Is the control diagram missing the connection circled in red?

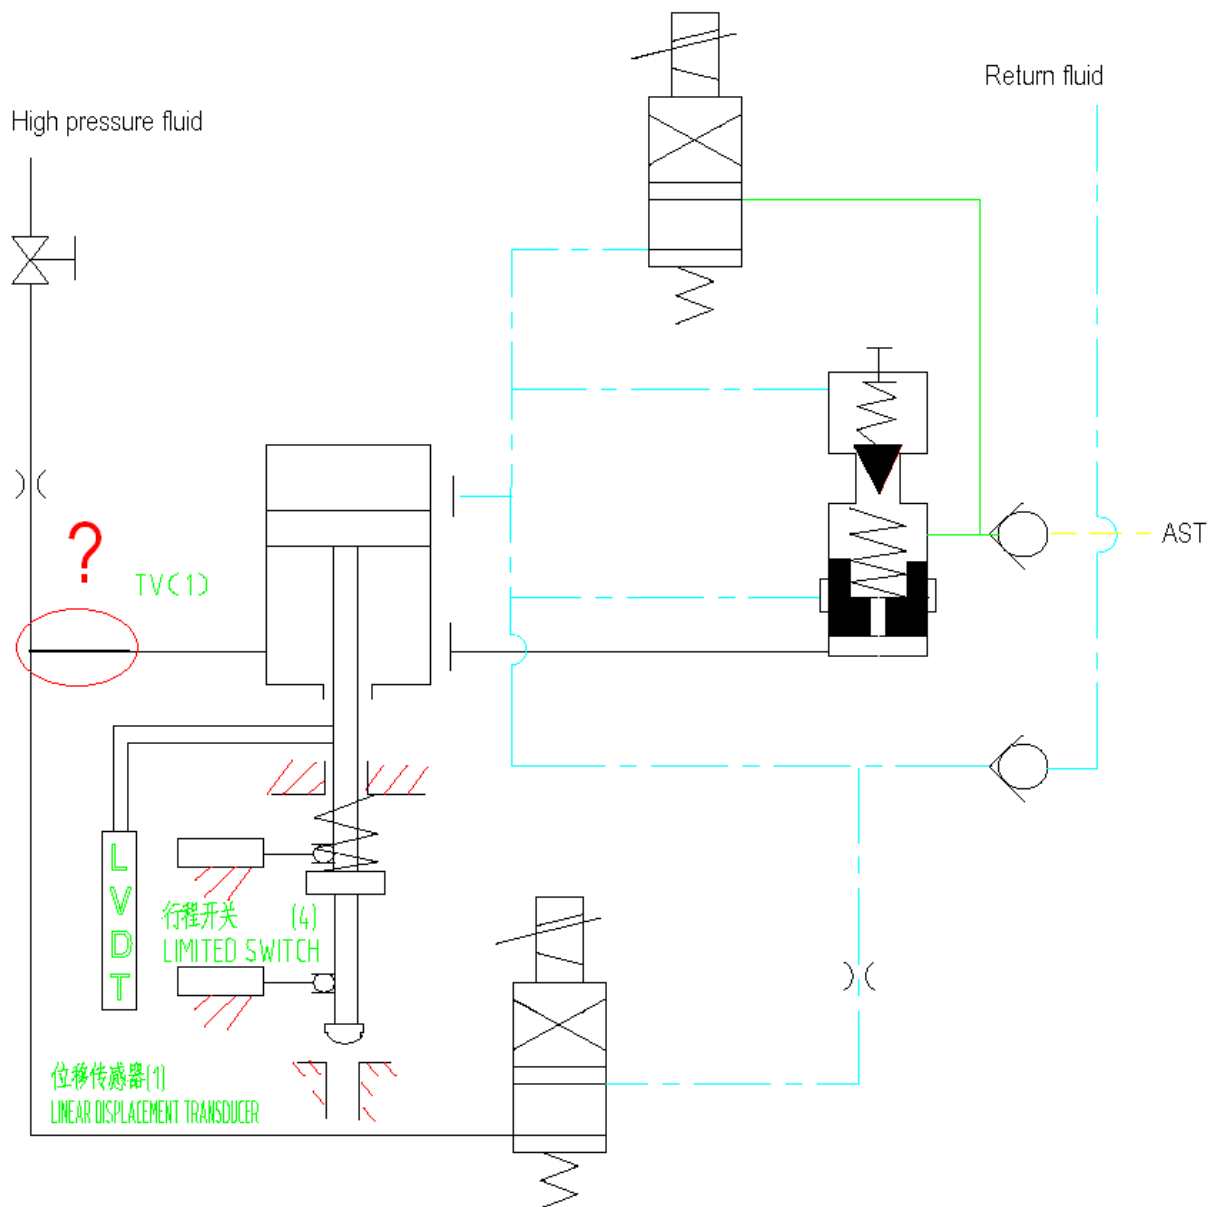
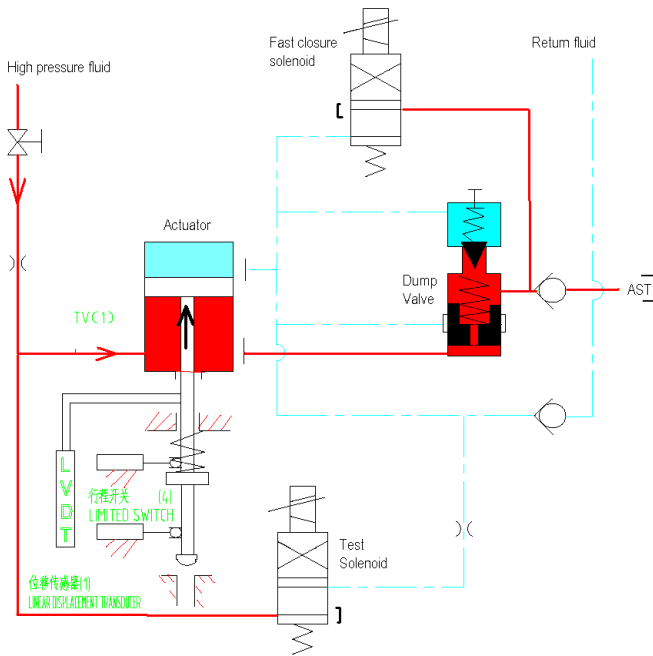
If as shown above;

High pressure fluid, through the isolation valve and orifice is admitted into the actuator. With the unit reset, the AST header blocks the flow of high pressure fluid and pressure builds in the actuator to open the TV.

The de energized test solenoid blocks high pressure. When energized, the solenoid drains the orifice supplied high pressure fluid that was being admitted into the actuator. The pressure drop determined by the orifices and the actuator spring cause the TV to close.
